**Proposal #31: 7831-07-70, WISC 2021 187
CTH AF – STH 27
Bridge Creek Bridge B-18-0238
CTH V
Eau Claire County**

This is Addendum No. 01, which provides for the following:

ADDENDUM NO. 01

7831-07-70

Addendum No. 01
ID 7831-07-70
Revised Sheet 15
January 25, 2021

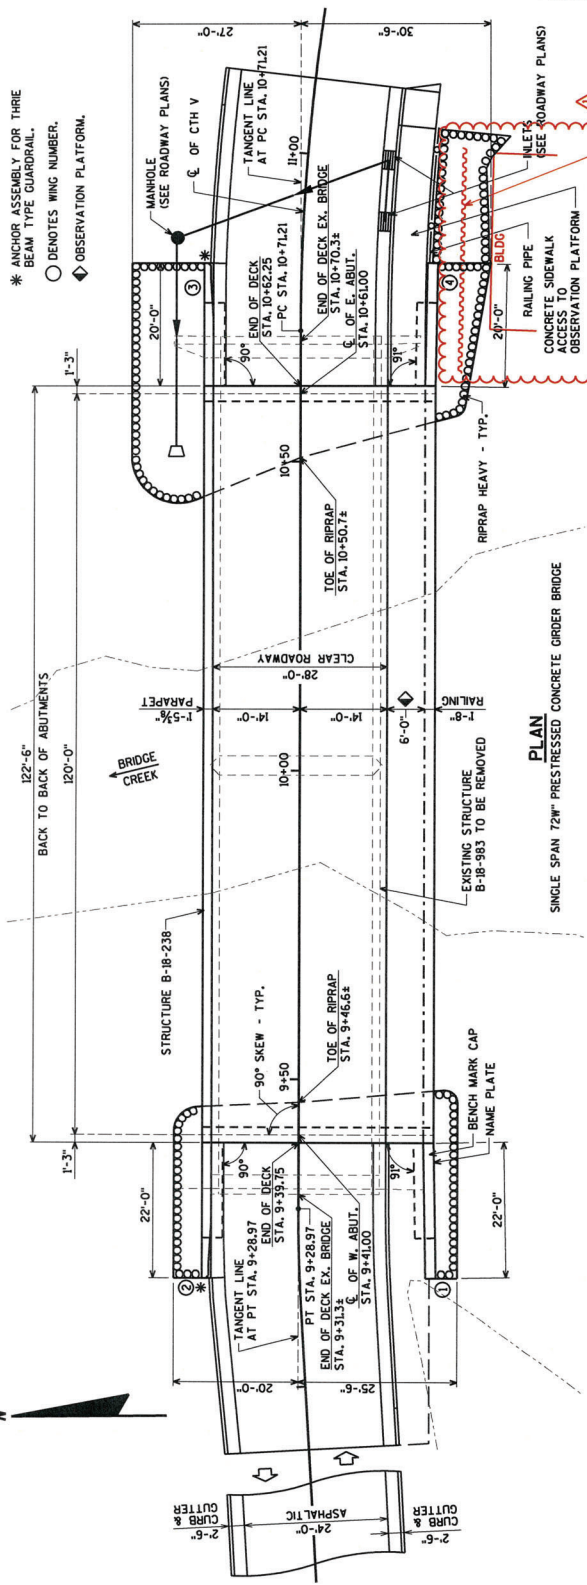
Revised Plan Sheets	
Plan Sheet	Plan Sheet Title (brief description of changes to sheet)
15	Miscellaneous Quantities: Revised traffic control quantities
46	Structure B-18-238 General Plan: Added Temporary Shoring to Plan View
48	Structure B-18-238 Quantities, Notes and Details Plan: Added Temporary Shoring, Seismograph, and Crack and Damage Survey to quantities table

Addendum No. 01
ID 7831-07-70
Revised Sheet 46
January 25, 2021

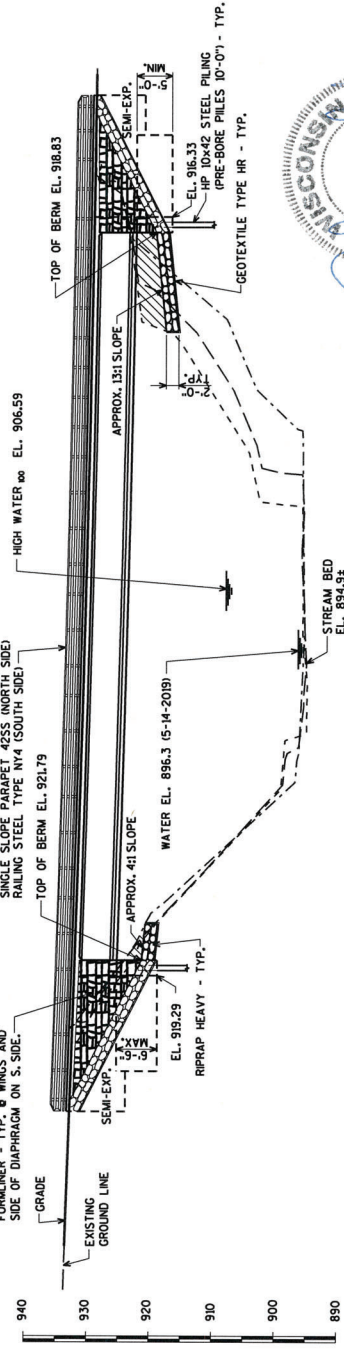
NO.	DATE	REVISION	BY
1	1/21	UPDATE TO QUANTITIES, ADD TEMPORARY SHORING	AYRES
